# RETREAT AT TIMBERRIDGE FILING NO. 3

## COUNTY OF EL PASO, STATE OF COLORADO

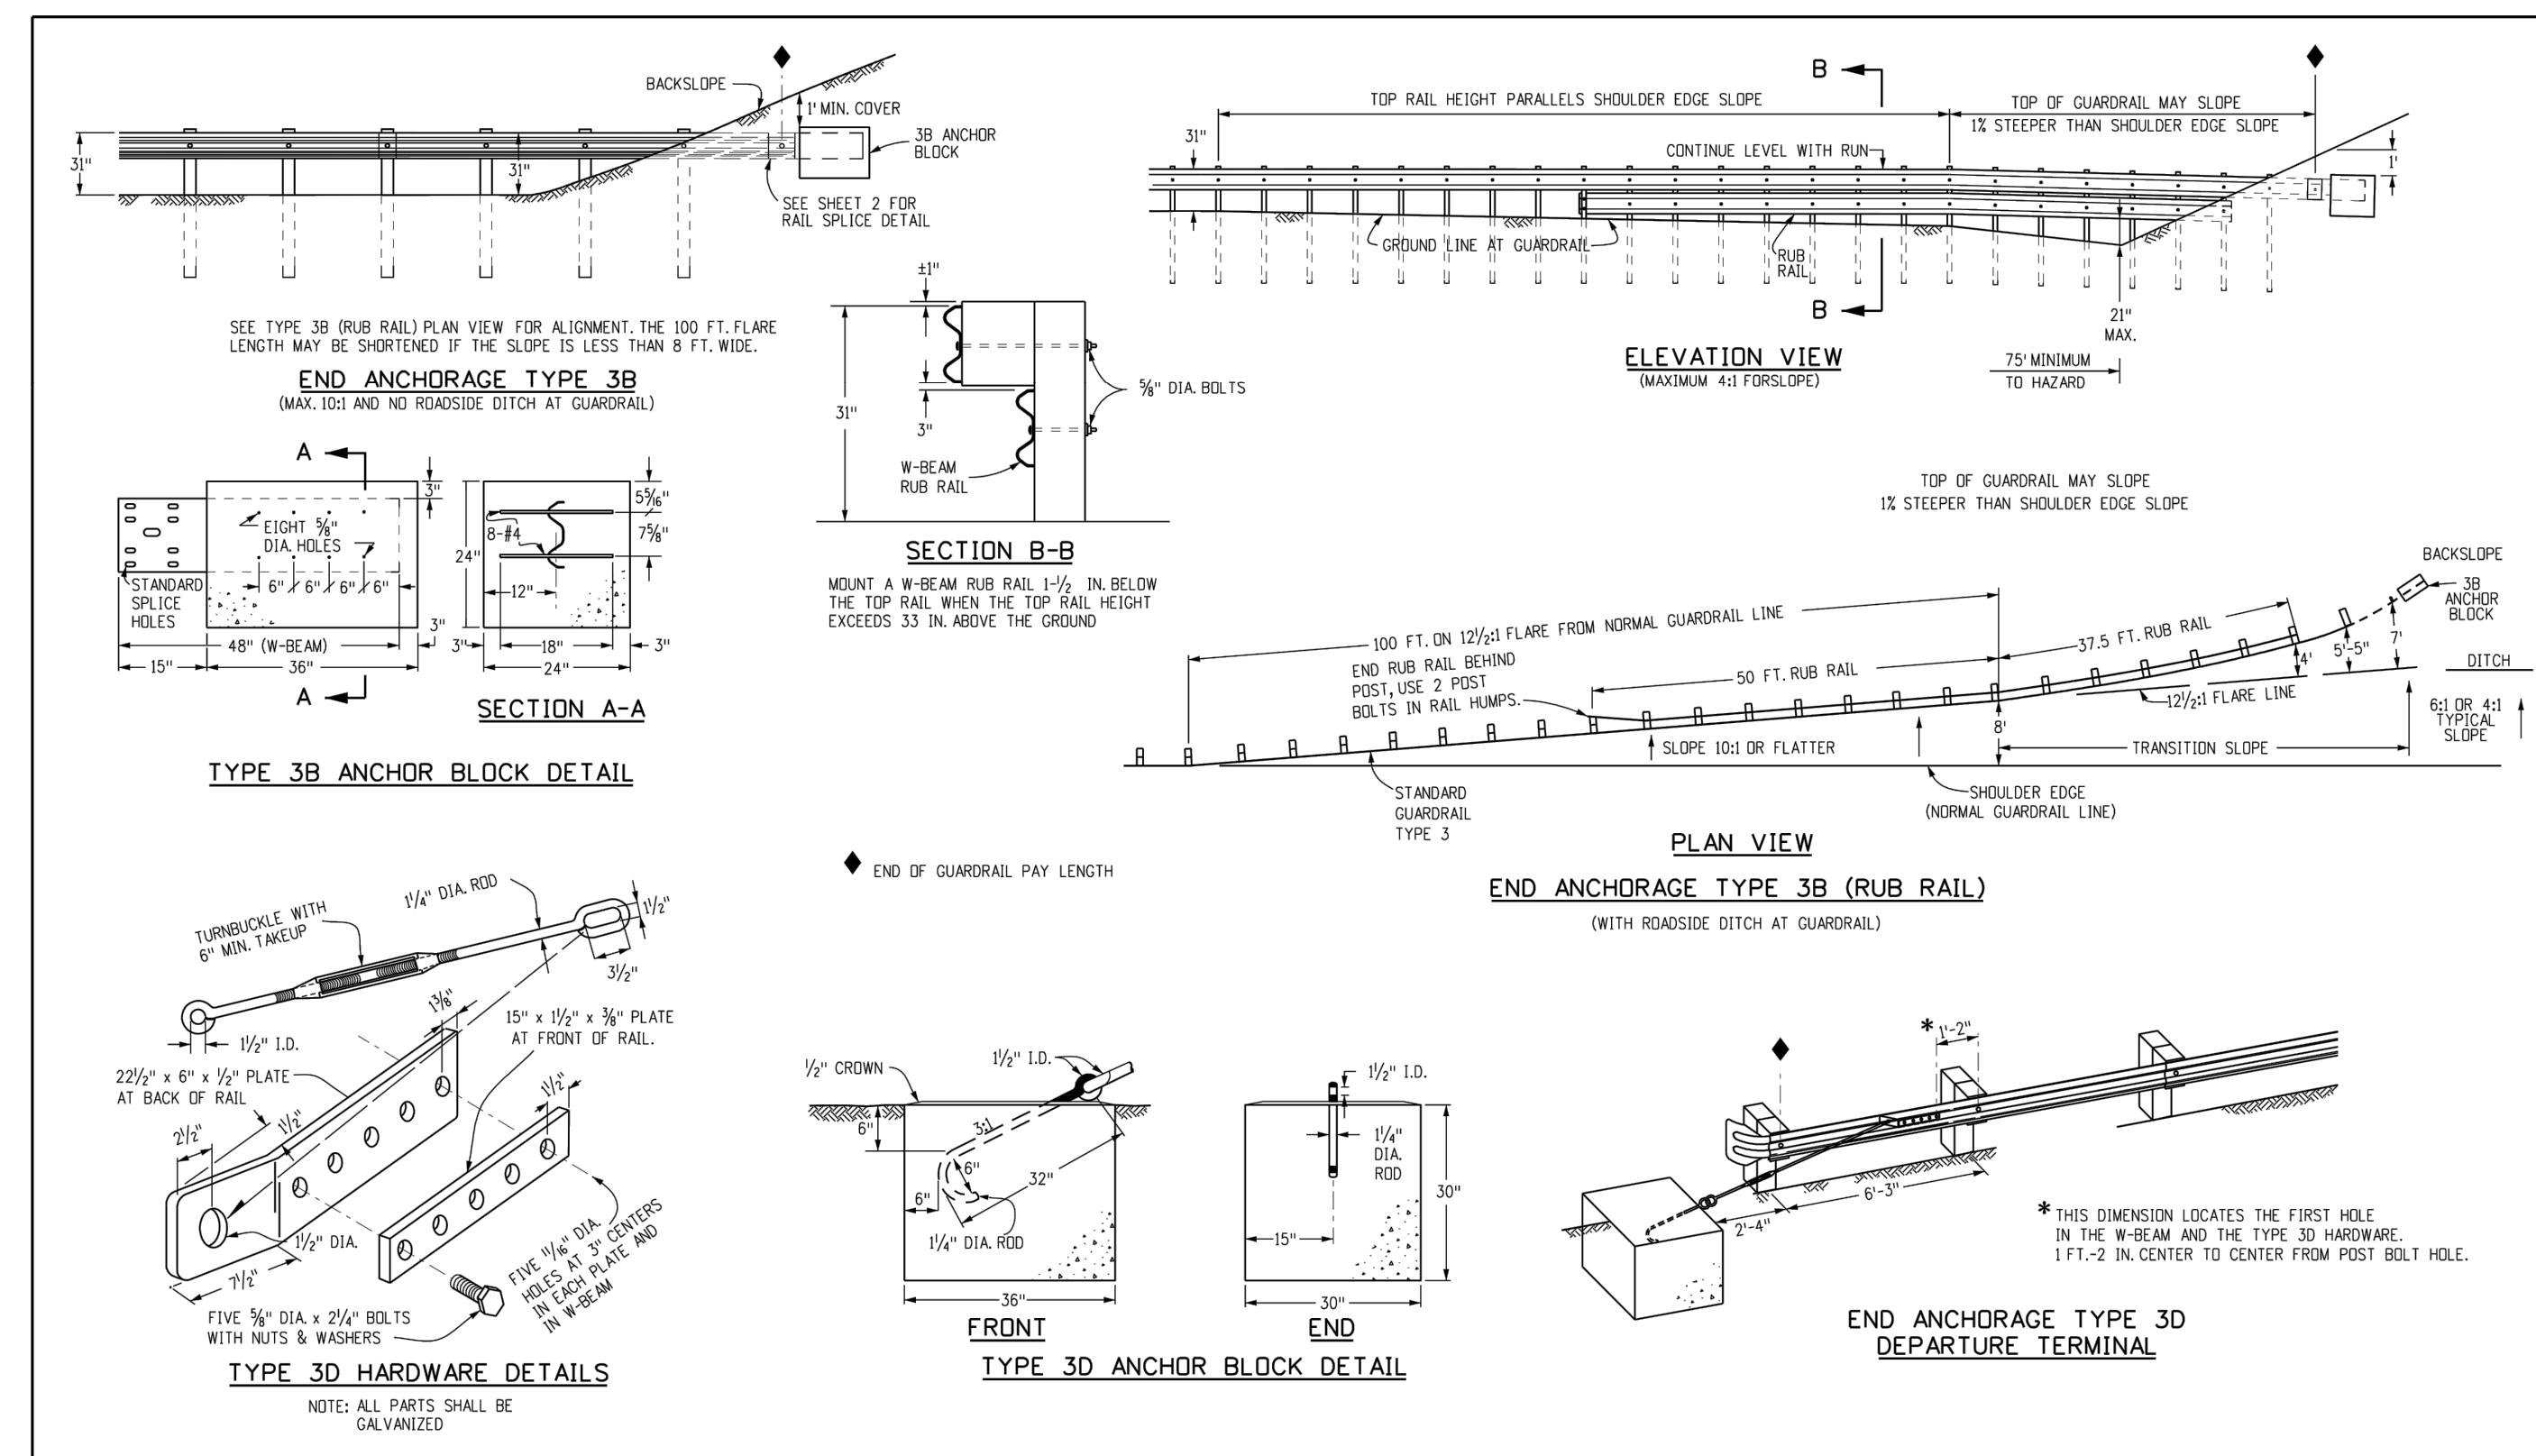
<b>Computer File Information</b>		<b>Sheet Revisions</b>		<b>Colorado Department of Transportation</b>		<b>MIDWEST GUARDRAIL SYSTEM (MGS) TYPE 3 W-BEAM 31 INCHES</b>		<b>STANDARD PLAN NO. M-606-1</b>	
Creation Date: 07/31/19	Designer Initials: JBR	Date: 03/05/20	Comments: Revised per Note 1 to show MASH compliant	2829 West Howard Place	CDOT HQ, 3rd Floor	Denver, CO 80204	Phone: 303-757-9021 FAX: 303-757-9868	Standard Sheet No. 5 of 19	Project Sheet Number:
Last Modification Date: 03/05/20	Detailer Initials: LTA			<b>Project Development Branch</b>		<b>JBK</b>		Issued by the Project Development Branch July 31, 2019	
CAD Ver: MicroStation V8	Scale: Not to Scale	Units: English						Project Sheet Number:
